Refere nce	DW Deadline 5 comments	National Highways Response	DW Deadline 9 response
9.69.11 I mention this first because lens through which to view serve to explain some of the inconsistencies and frankly which you will see resulting chapter and the next.  The HE-modelled 2025-D/J4 is almost certainly in because as the charts clear figure is almost exactly the ATC-based model baseline that the 2019 DfT ATC figurent that it is almost certainly ure length almost certainly incorrect to be consistent with the M this is the main route into a comparisons between 20 are then in turn also invaluated itself is suspect.  These comparisons are us automatic scoping out or set of assessments on the grown have not been met, such a fino. of vehicles AADT must so all these automatic scoping out decisions are invalidated. FTAOD this limited to noise, vibration, waccidents, air quality of all final are comparisons, air quality of all finited to noise, vibration, waccidents, air quality of all finited to noise, vibration, waccidents, air quality of all finited to noise, vibration, waccidents, air quality of all finited to noise, vibration, waccidents, air quality of all finited to noise, vibration, w

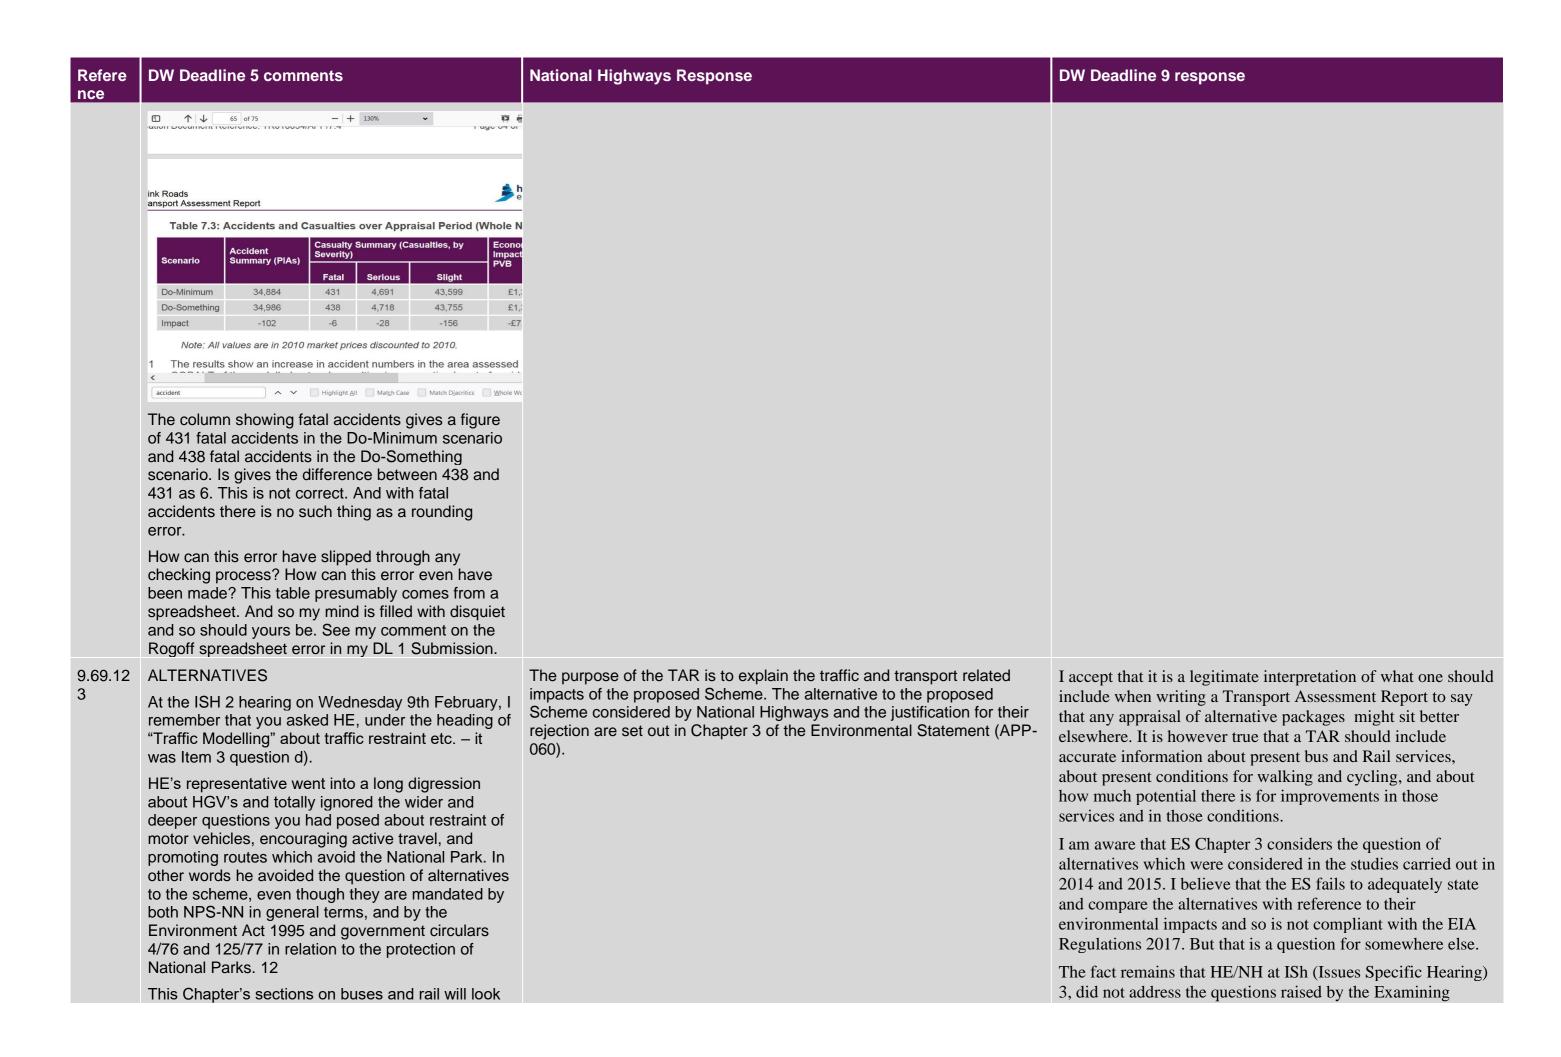
9.69.11	1 The DM-2025 flow predicted for the M67 J 3 / 4 location cannot be correct.  If this is true then the entire model is put in doubt, and so I myself was in doubt over it. It seemed extraordinary that this could be possible. Maybe there was a way that HE's 2015 counts-based figure could be the same as the figure predicted by the model for DM-2025?	See response to 9.69.114 above.	See my reply to that response
	I went into a loop of researching whether traffic on roads similar to the M67 or A57 had been static from 2015 onwards up to the pandemic. Then it could make sense that a DM-2025 modelled figure might actually be the same as the 2015 counts. In the Road Traffic Estimates in Great Britain – 2019 I found official Department for Transport (DfT) graphs showing the growth in traffic on motorways, on urban A roads, and on the SRN. <sup>1</sup>

Defere	DW Deadline Framments	National Highways Doomanas	DW Deadline O response
Refere nce	DW Deadline 5 comments	National Highways Response	DW Deadline 9 response
	research I went back and had another look at the relevant bar chart (slide 14). The answer was right there staring me in the face. <sup>2</sup> The 2019 figure, which is a Department for Transport automatic traffic count (ATC) figure, is far higher (24% higher) than the 2015 HE baseline figure.		
	And so the conclusion stands. It is utterly implausible that DM-2025 should be the same as HE2015, and therefore it is virtually certain <sup>3</sup> that the DM figure is wrong.
